# SERVICE BULLETIN

**SUBJECT:** ONE-TIME INSPECTION AND REPLACEMENT OF TAIL ROTOR FORK BOLT (369A1602).

**MODELS AFFECTED:** All MD Helicopters, Inc. (MDHS) 369H Series helicopters, including 369A (OH-6A), 369D, 369E and 369F/FF Series helicopters equipped with uninscribed or 369A1602-BSC tail rotor fork bolts. All tail rotor fork bolts and tail rotor assemblies in Spares inventories.

Figure 1. Inspection of Tail Rotor Fork Bolt.

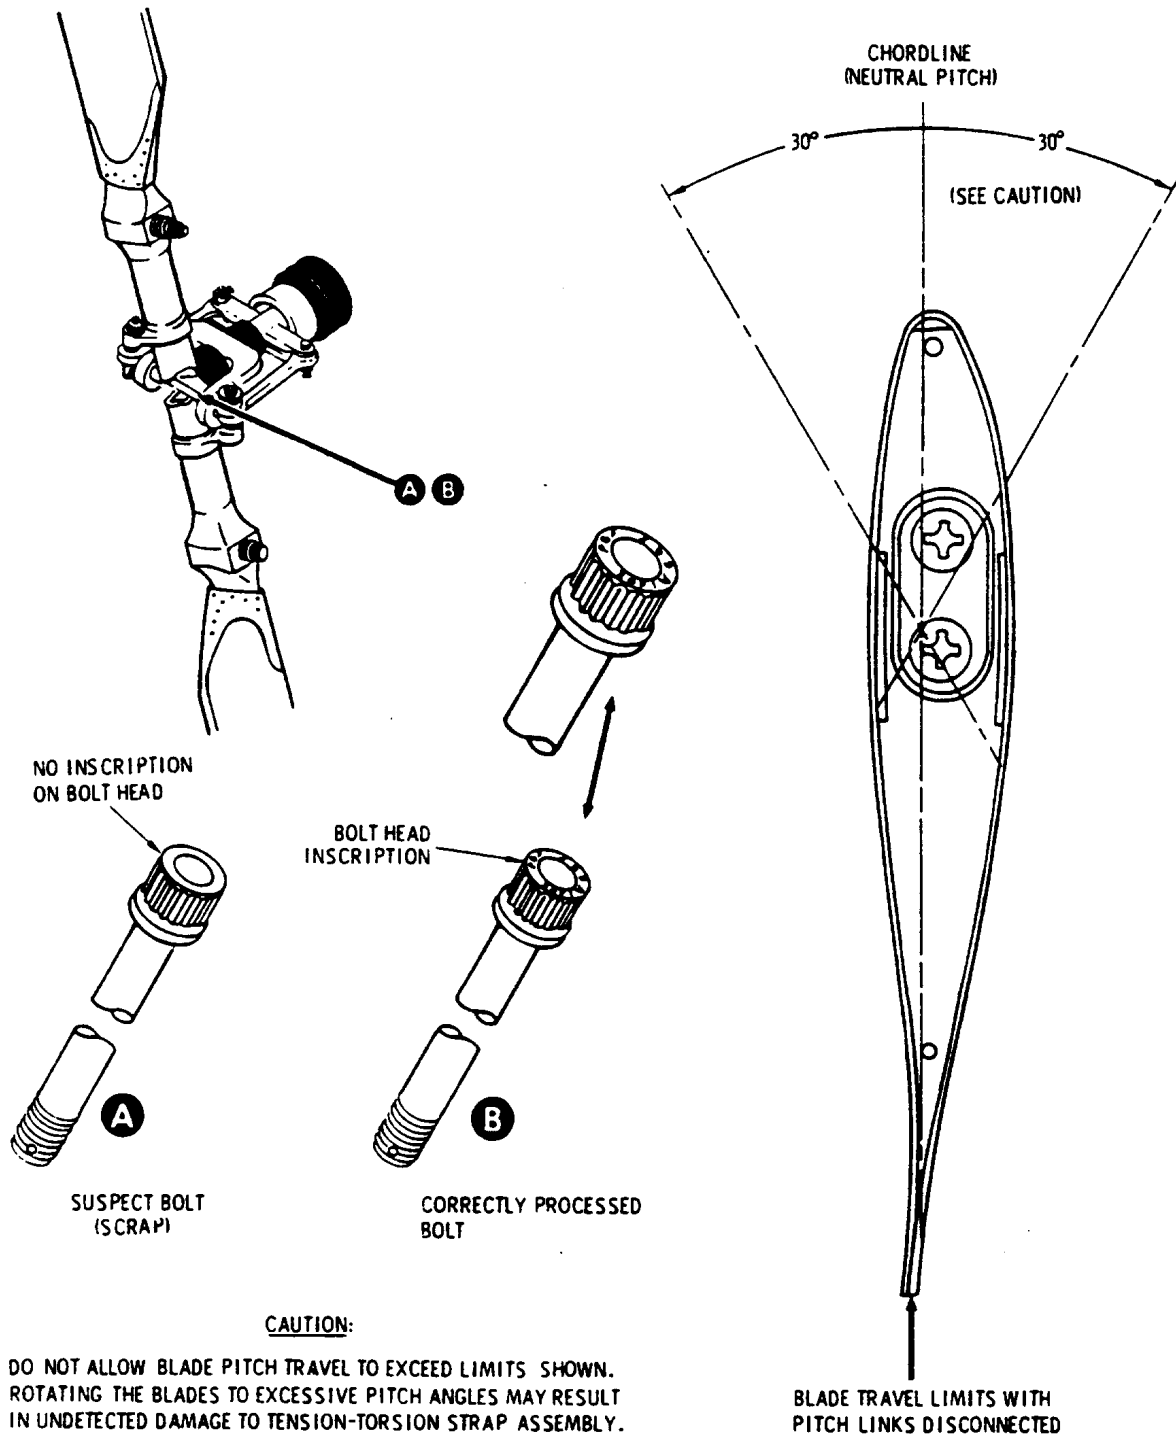
- a. Visually inspect all Spares inventories and tail rotor fork bolts installed on helicopters and tail rotor assemblies for proper inscription on the head of the bolt (see Figure 1 ).

- Uninscribed tail rotor fork bolts on helicopters shall be replaced, proceed to **Part II**.
- Remove all uninscribed tail rotor fork bolts from Spares inventories and scrap those fork bolts.

- When the blade and hub assembly is removed from the helicopter, and at all times when the pitch control links are disconnected, **DO NOT** allow blade pitch to exceed 30 degrees from neutral position (see Figure 1). This is equal to blade pitch control movement of approximately one inch in either direction. Unrestricted rotation of blades on hub can excessively bend or stretch strap pack assembly and cause undetected damage to tail rotor assembly when reassembled.
- Do not remove hub-to-drive fork hinge bolt to remove tail rotor assembly. Damage to strap pack may occur.

- A MS21206C4 washer must be installed with a 369A1602-3 tail rotor fork bolt.
4. Install a 369A1602-3 fork bolt along with a MS21206C4 washer with the countersunk side towards the bolt head and reassemble hub and fork unit (HMI Appendix C and Component Overhaul Manual, Part VII).
  5. Perform testing and balancing procedures (HMI Appendix C, Part VIII and Component Overhaul Manual, Part VII).
- b. Record compliance with Part II of this Notice in the Compliance Record section of the helicopter Log Book.
